Service Bulletin

**MONOGRAM
REFRIGERATOR
ICING KIT WR49X10021**

REF 16-00

August 2000

MONOGRAM FREEZER ICING KIT WR49X10021

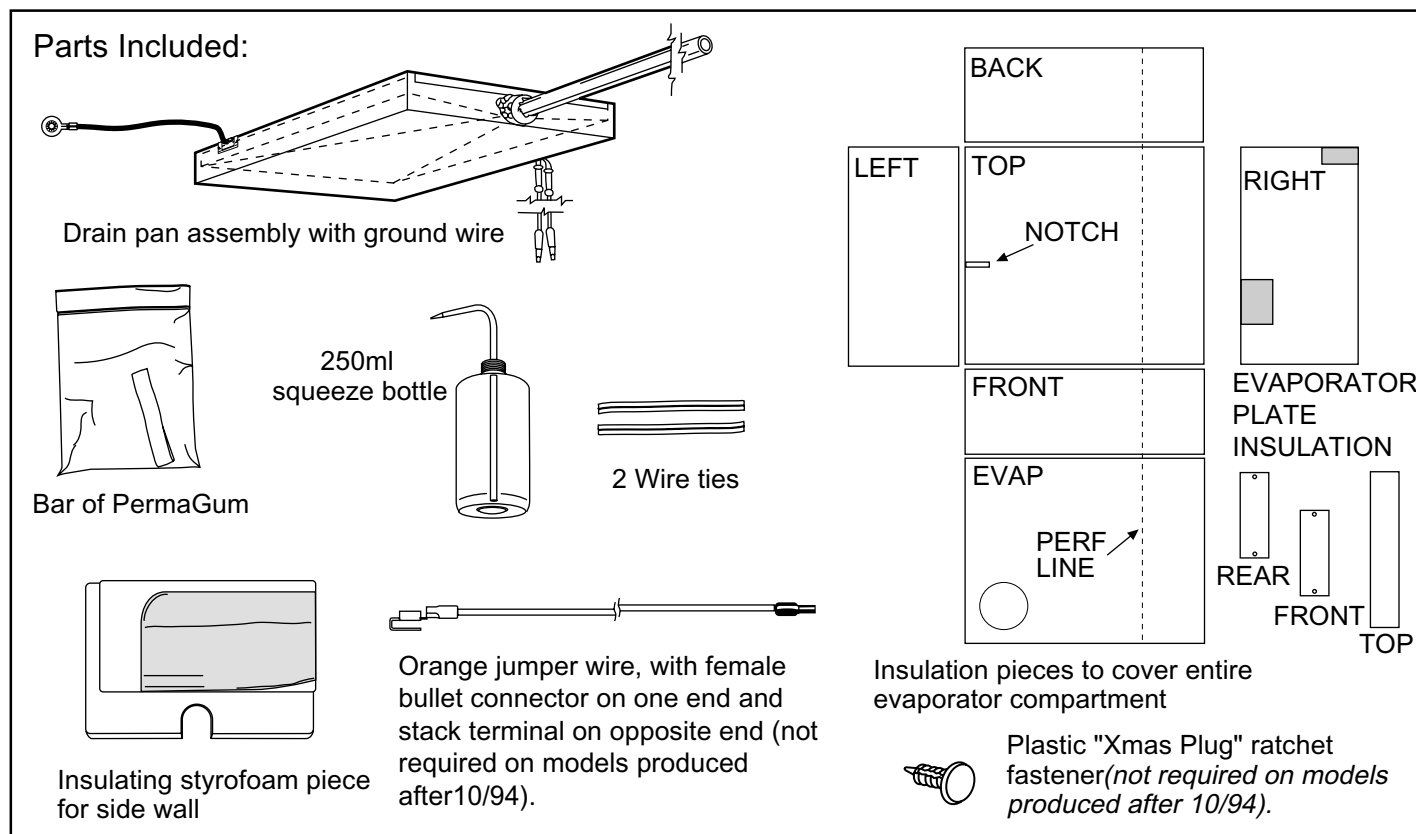
The Monogram freezer icing kit WR49X10003 has been upgraded for all Monogram Side by Side 36", 42" and 48" models produced 1992 until present. The upgraded kit is catalogued as part **WR49X10021** and will supersede the WR49X10003 kit. The improvements made to the kit include a longer drain pan, an antifungal drain tube, a redesigned styrofoam insulator for the right freezer wall, the addition of foam insulation for the evaporator compartment and improved installation instructions.

NOTE: IT IS EXTREMELY IMPORTANT TO FOLLOW THE KIT INSTRUCTIONS CLOSELY. CARE MUST ALSO BE TAKEN NOT TO CRACK THE FRONT EDGE WHEN INSTALLING THE NEW DRAIN PAN FOAM HOUSING.
